SUBJECT: HADDAM NECK PLANT - RELEASE OF LAND FROM PART 50 LICENSE

SAFETY EVALUATION BY OFFICE OF FEDERAL AND STATE MATERIALS

RELATED TO THE RELEASE OF LAND FROM FACILITY OPERATING LICENSE NO. DPR-61

HADDAM NECK PLANT

Figure 1. Overview of Connecticut Yankee Land Area Phases

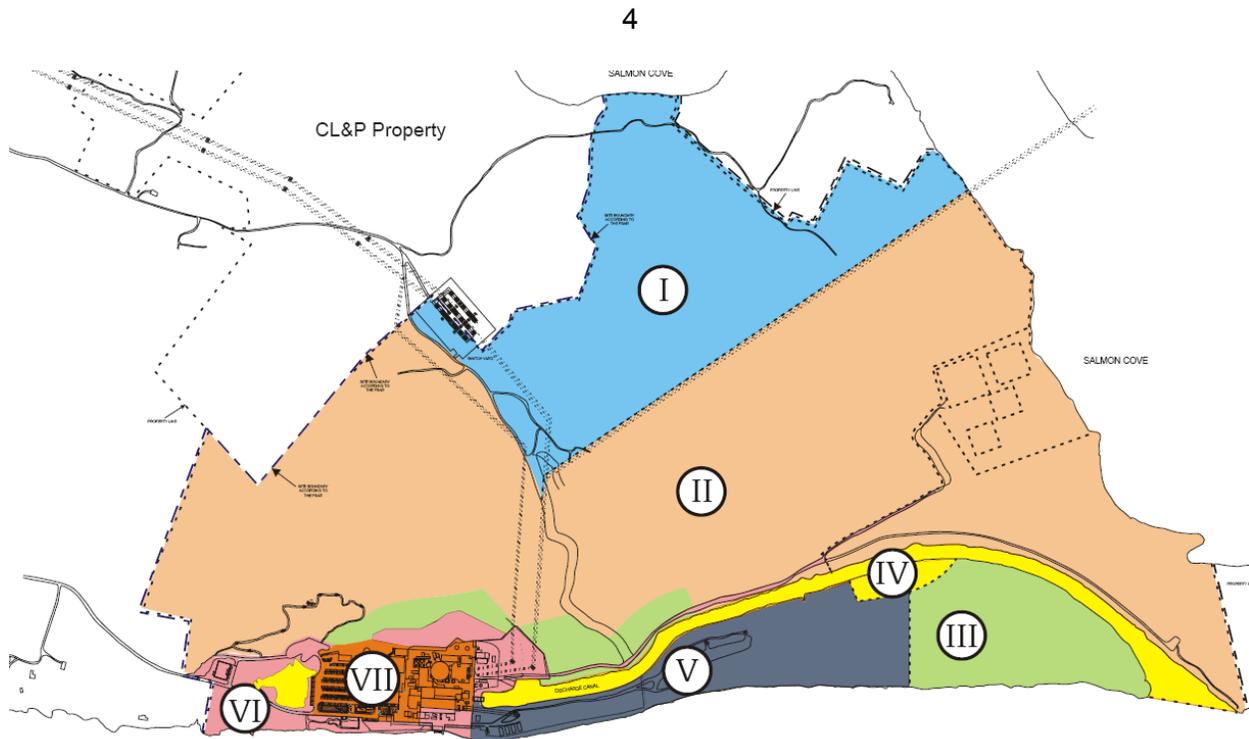
The specific survey areas to be released are described below in phases, consistent with the FSS reporting, and depicted in Figure 1.

Phase I was comprised of survey unit (SU) 9532, the east side grounds of the site which were determined to be unimpacted by site operations. This SU encompassed 375,600 square meters (m²), and was released from the site in September 2004 (ADAMS Accession Number ML042510091).

Phase II was comprised of fifteen (15) SU's: 9523-0000, 9524-0000, 9525-0000, 9526-0000, 9526-0001, 9526-0002, 9528-0000, 9528-0003, 9528-0004, 9535-0001, 9535-0002, 9536-0000, 9537-0000, 9538-0000, and 9806-0000. Phase II included SU's of various contamination classifications, as defined in the HNP LTP, but did not include areas with potential future groundwater contamination. These SU's encompassed 907,648 m² of site land and were released from the site on February 27, 2006 (ADAMS Accession Number ML060530075).

Phase III is comprised of seven (7) SU's: the southeast pond, 9521-0000; the east mountainside, 9527-0001 through -0004; the southeast mountainside, 9528-0002; and the south end of the peninsula, 9531-0000. These SU's total 173,470 m² and are HNP LTP class 2 and 3 areas, with existing groundwater contamination in all but the south end of the peninsula. Groundwater contamination dose contributions are discussed in the Groundwater section below.

Phase IV is comprised of sixteen (16) SU's in the discharge canal (SU's 9106-0001 through 9106-0011, 9106-14, and 9106-15), permanent wetlands (SU's 9106-0012 and 9106-0013), and the pond (9508-0000). The SU's are sediment bearing HNP LTP class 1, 2, and 3 areas, and five SU's have existing groundwater contamination. Groundwater contamination dose contributions are discussed in the Groundwater section below.

Phase V is comprised of twelve (12) SU's in the southwest site storage area (SU's 9520-0001 through 9520-0006, and 9805-0000), the central peninsula (SU's 9530-0001 through 9530-0004, and 9807-0000). The SU's are HNP LTP class 1, 2 and 3 areas. Two of the SU's are subsurface (9805-0000 and 9807-0000) and all have existing groundwater contamination. Groundwater contamination dose contributions are discussed in the Groundwater section below.

Phase VI is comprised of seventeen (17) SU's in the southwest protected area (SU's 9304-0001 and -0002), the bypass road and secondary parking lot (SU 9504-0000), the north site grounds (SU 9506-0000), the northwest site grounds (SU's 9512-0000, 9522-0001 through -0007, the east mountain side (SU 9527-0005 and -0006), the Independent Spent Fuel Storage Installation (ISFSI) haul road (SU 9539-0001 and -0002), and the subsurface area associated with the southeast grounds (SU 9804-0000). The SU's are HNP LTP class 1, 2, 3, and C areas. One of the SU's is subsurface (9804-0000), all but the north site grounds (SU 9506-0000) have existing groundwater contamination, and seven have future groundwater dose contributions (SU 9304-0001, 9304-0002, 9522-0005, 9522-0006, 9522-0007, 9539-0002, and 9804-0000). Groundwater contamination dose contributions are discussed in the Groundwater section below.

Phase VII is comprised of eighteen (18) SU's in the northwest protected grounds (SU 9302-0000); the southwest protected grounds (SU 9306-0000); grounds (SU 9312-0001) and areas within the former containment radiologically controlled area (RCA), including the footprint of the spent fuel building footprint (SU 9312-0002), the former southwest 115 kilovolt (kV) switchyard (SU 9312-0003), the area north of the former Primary Auxiliary Building (PAB) (SU 9312-0004), the former tank farm (SU 9312-0005), the PAB footprint (SU 9312-0006), the Radwaste Reduction Facility (RRF) footprint (9312-0007); the groundwater treatment facility footprint (9312-0008), the east trench (9312-0009 and 0010), the central site grounds (9313-0000), the primary parking lot (9514-0000 and 9514-0001), and the subsurface areas of the industrial grounds and RCA (9801-0000, 9802-0000, and 9803-0000).
